SUBJECT: Corrective Actions resulting from DHSR
Construction Section Biennial Survey 6-28-19. for
Trinity Oaks Assisted Living License # HAL 080010.

STATEMENT OF DEFICIENCIES AND PLAN OF CORRECTION	(X1) PROVIDER/SUPPLIER/CLIA IDENTIFICATION NUMBER: HAL080010	(X2) MULTIPLE CONSTRUCTION A. BUILDING: 1D B. WING: _____	(X3) DATE SURVEY COMPLETED 06/28/2019
--	---	---	--

RE: HA Biennial Survey (6/28/2019)
Trinity Oaks Continuing Care
728 Klumac Road
Salisbury (Rowan County)
FID # 931257; HA 1080010

CEILING REMEDIATION

FLOOR PLAN
SCALE: 3/32" = 1'-0"

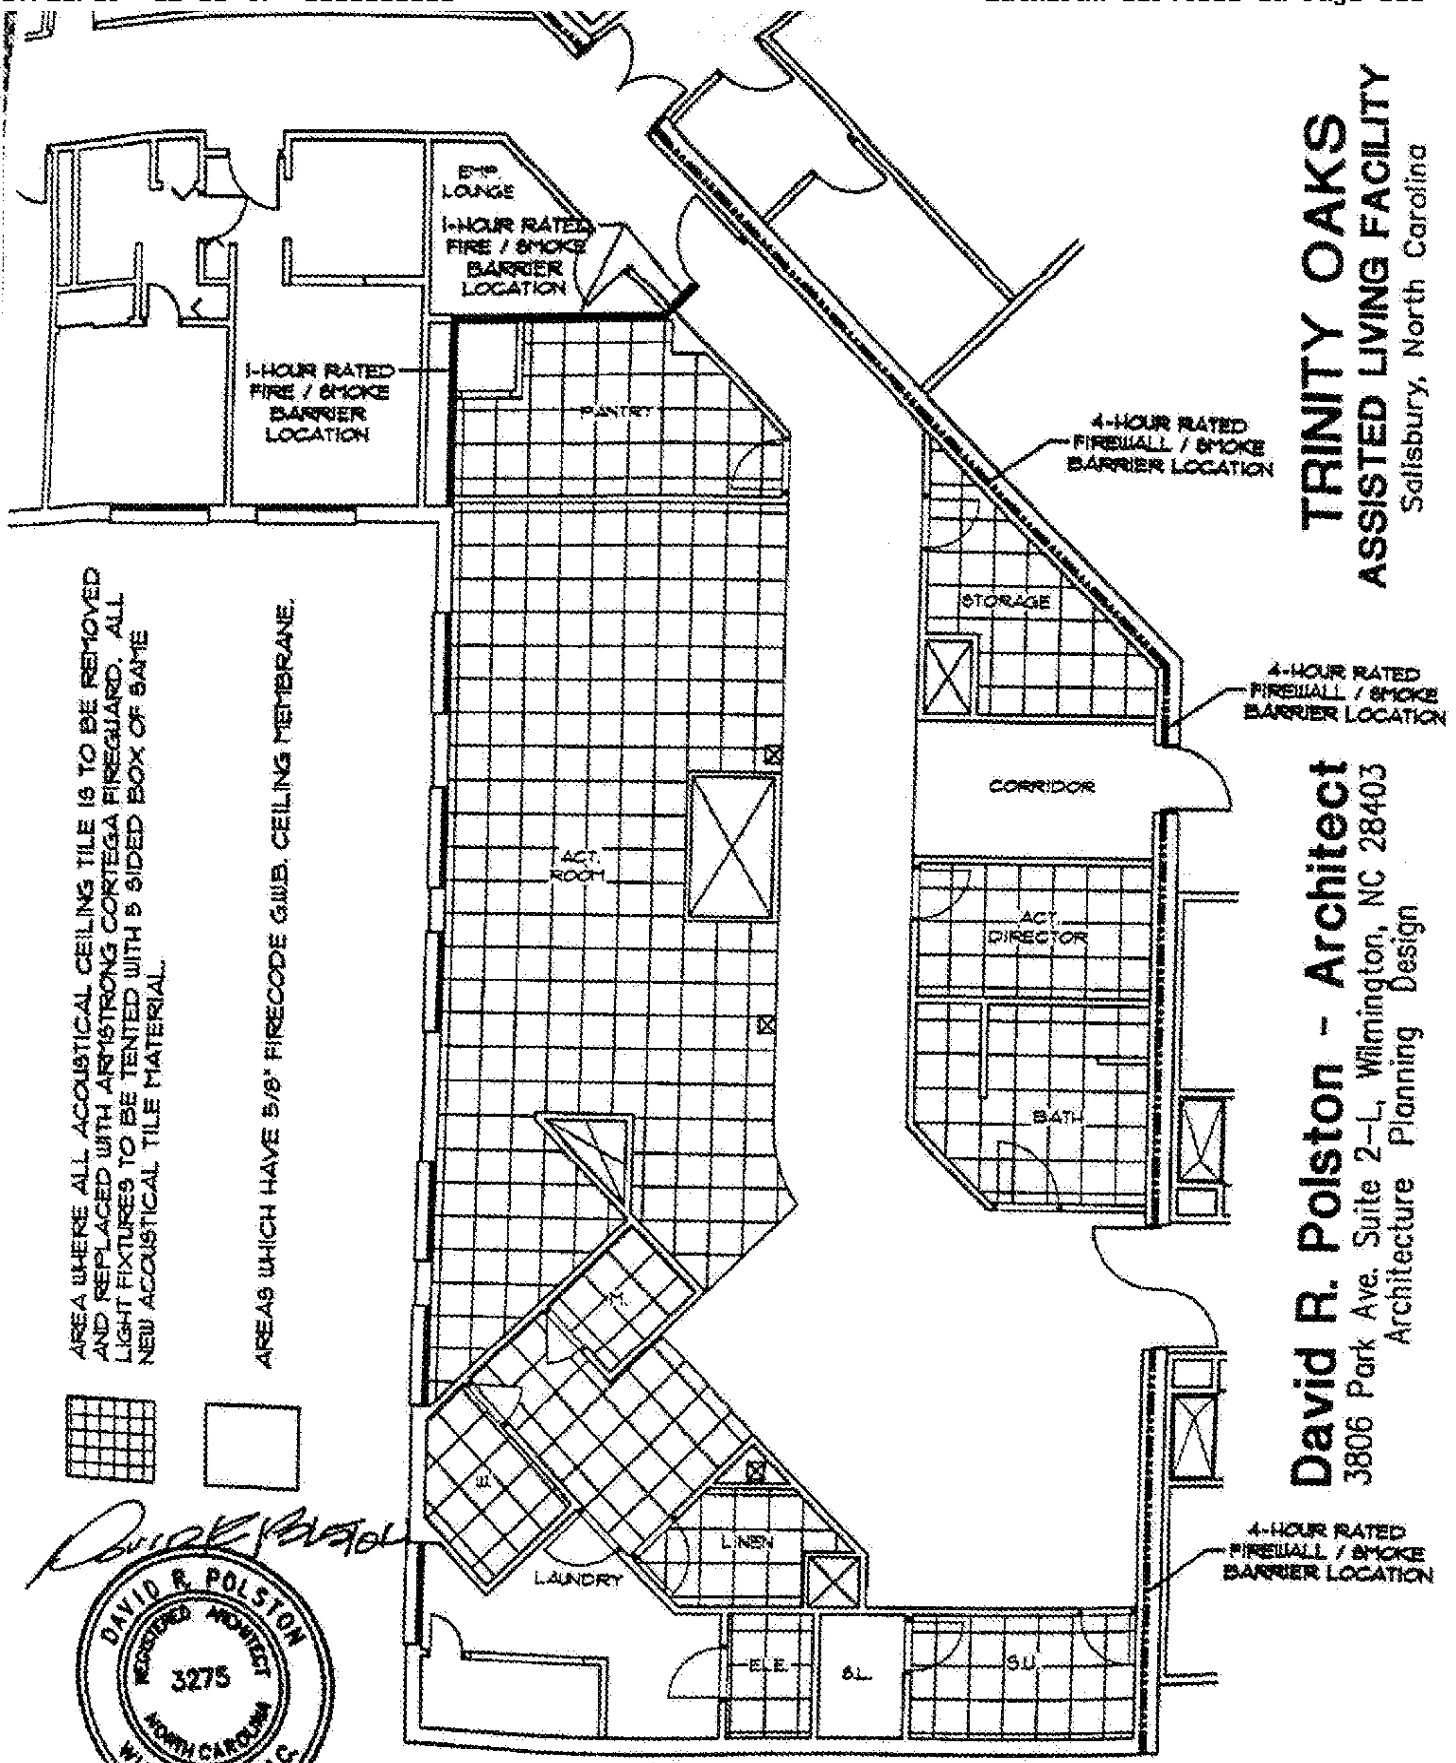
a. Old Wing - the facility is required to have a one-hour fire-resistance-rated roof/ceiling assembly to protect the noncombustible construction above. The existing acoustical ceiling tiles are not a part of an approved one-hour roof/ceiling assembly. These tiles are not marked with an UL or similar testing laboratory approval stamp. They are also not heavy enough. Provide an approved roof/ceiling assembly, assuring that the exit grid is acceptable with the new one-hour fire-resistance-rated roof/ceiling assembly and if not, replace grid. All penetration must be properly firestopped.

Based on my on-site observations, review of the original construction drawings and review of the UL assembly components, it appears that ceiling tiles must be replaced and the light fixtures protected. Attached is a floor plan of the "Old Wing" identifying the areas for tile replacement. The UL L209 lists Armstrong tiles as an acceptable manufacturer. We have instructed the owner

to replace all acoustical ceiling tile with Armstrong Cortega Fireguard (Item #824). This tile is tested for the 1 Hour assembly and weighs 1.09 LBS/SF. I have also instructed the owner to tent the light fixture with a 5 sided box constructed of the same Armstrong Cortega Fireguard. The tenting of the light fixture with the acoustical material complies with UL 1209 requirements.

AREA WHERE ALL ACOUSTICAL CEILING TILE IS TO BE REMOVED AND REPLACED WITH ARMSSTRONG CORTEGA FIREGUARD. ALL LIGHT FIXTURES TO BE TENTED WITH 5 SIDED BOX OF SAME NEW ACOUSTICAL TILE MATERIAL.
